TE Connectivity

Product Change Notification: E-19-009293

General Product Description:
RF Connector

<p>Before</p> 	<p>After</p> 
--	--

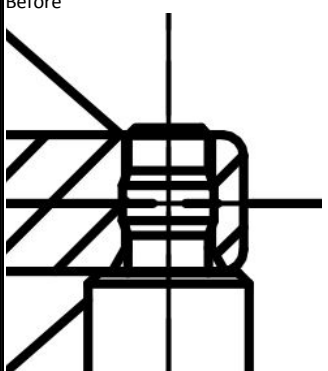
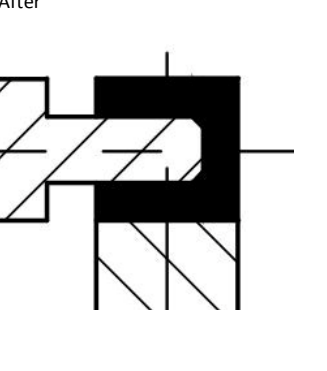
Description of Changes
update the structure of half center contact from press-in to solder. please refer to attached pic.

Reason for Changes:
Product Improvement. soldering type is more reliable for two components linked together.
